भारतीय विमानपत्तन प्राधिकरण  
AIRPORTS AUTHORITY OF INDIA

Subject: -Submission of AAI's comments in response to consultation paper no 06/2025-26 in the matter of determination Aeronautical Tariff in respect of Tiruchirappalli International Airport

Response to Airports Economic Regulatory Authority (AERA)'s Consultation Paper No. 06/2025-26 dated 27<sup>th</sup> February 2026 Determination of Aeronautical Tariff for Tiruchirappalli International Airport for the 2<sup>nd</sup> Control Period (01.04.2025 - 31.03.2030).

## Reconfigured Terminal Building Layout - Departure Plan

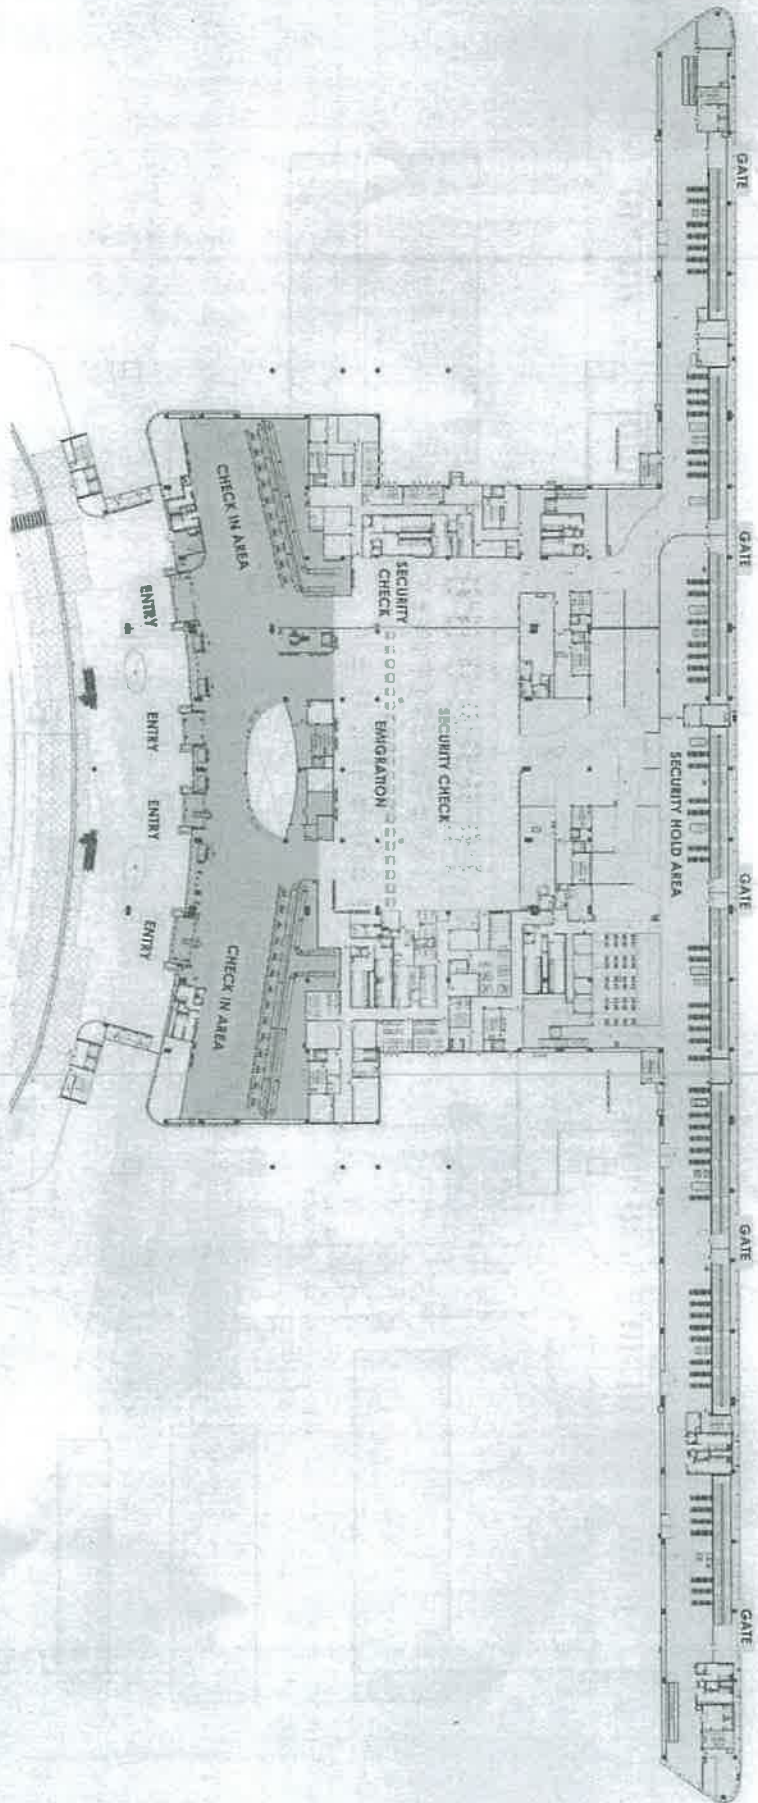
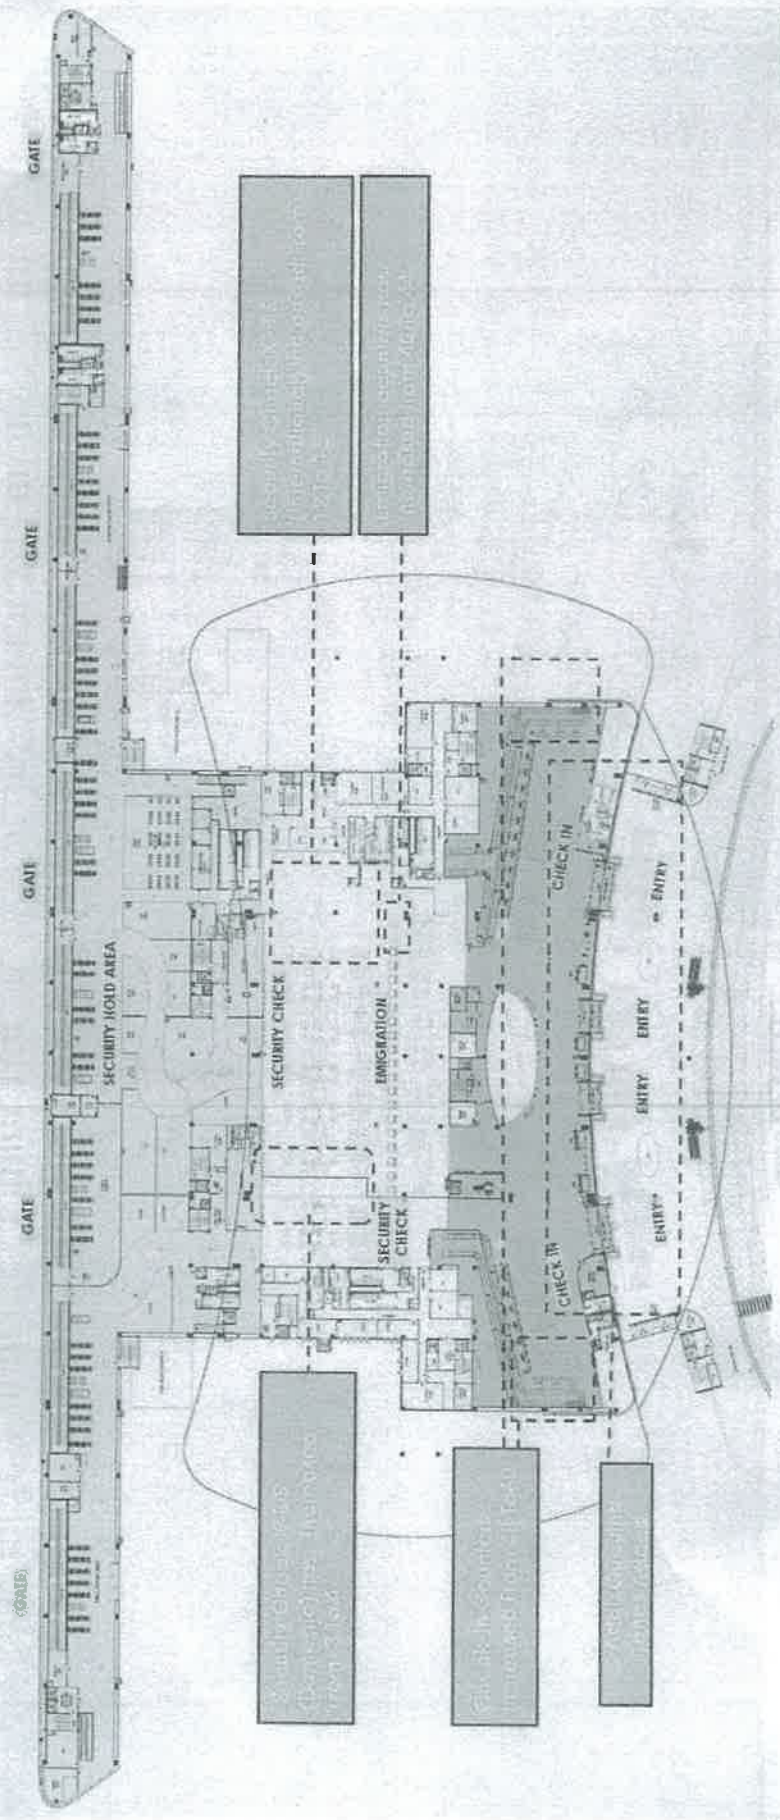
- 4.5.6 Further, Authority notes that AAI has reconfigured the terminal design capacity of Tiruchirappalli International Airport from 3.63 MPPA to 4.45 MPPA. The actual traffic during FY 2024-25 was 1.95 MPPA which was slightly above the traffic projected by the Authority in the Tariff Order of the First Control Period. But due to higher reconfigured terminal design capacity, the actual utilisation of the terminal continues to remain less than 50% of the revised design capacity. As per the IMG norms, the terminal building should be planned considering the traffic in the 10<sup>th</sup> year from the planning year. The terminal building was planned in FY 2019-20 considering the traffic of FY 2029-30, which is projected to be 3.03 MPPA, as submitted by AAI. The Authority notes that the projected traffic of 3.03 MPPA in FY 2029-30 is still below the original design capacity of 3.63 MPPA. Furthermore, the Authority notes that the terminal building is already underutilized and there was no need to reconfigure the terminal building. This reconfiguration has led to an increase in terminal

4.5.7 In view of the above and persistent underutilization, the Authority proposes to retain and allow the admissible capital cost at ₹853.10 crore, as per the original planning for 3.63 MPPA terminal building during First Control Period, so as to avoid imposing an undue tariff burden on passengers, who are the ultimate funders of such capital expenditure.

Therefore, to enhance the domestic peak hour capacity and extend the terminal's saturation year, a reconfiguration of the terminal building was planned and implemented. This resulted in an increase in the planned peak hour capacity to 3,480 passengers (2,400 international and 1,080 domestic). The annual capacity of the reconfigured terminal has been estimated at 4.45 million passengers per annum, based on traffic ratios in accordance with IMG norms.

The modifications were limited to internal adjustments within the existing building footprint. These included removal of partition walls, addition of check-in counters, augmentation of conveyor systems to support increased check-in capacity, and installation of additional X-BIS machines. These changes were aimed at improving space utilization, enhancing passenger flow efficiency, eliminating bottlenecks, and increasing overall peak hour handling capacity.

Only modification inside the building like removal of partition wall, providing additional counters, augmentation of conveyor due to increase in Check-in counters, providing additional XBIS in SHA was undertaken to meet the passenger peak hour capacity (PHP) mainly of domestic which was 600 (300 departure + 300 arrival)(in view of increase in domestic passengers from 20% to 40% and minimum two domestic flights in one hour as per slot allotment) for better space efficiency, increased passenger capacity, efficient flow of passengers, removal of bottlenecks and to increase the peak hour capacity of Terminal Building. Moreover, the modification work in conveyor cannot be carried out in the operational Airport.
